September 16, 2010

**Re: Construction Storm Water Inspection at Keny Road Extension Project
Madison County
Permit Number 4GC03299 *AG**

Figure 1: Barren area in need of erosion control

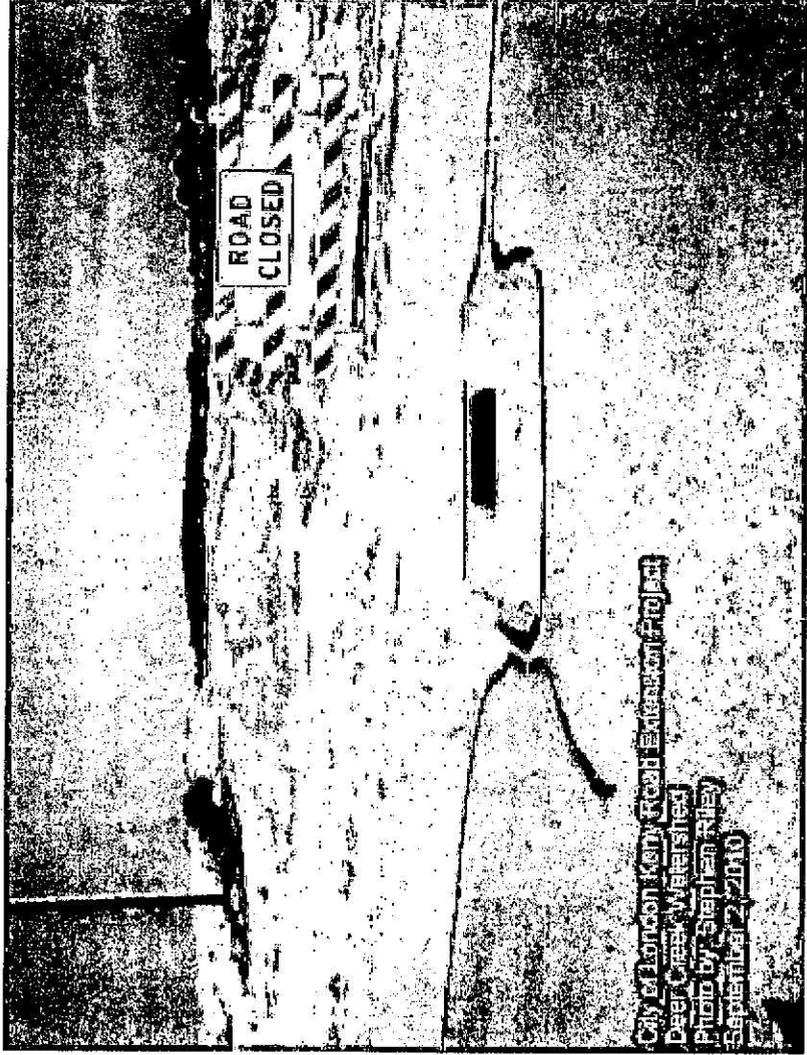
- At the last intersection before the Keny Road extension meets 38, there is a sloped barren area sloping towards the road (Figure 1). Be aware the General Permit states that all barren areas which remain idle in excess of 21 days must be protected from erosion within seven days of the last earth disturbing activities. In addition, erosion protection must be implemented for all areas of final grade within seven (7) days.
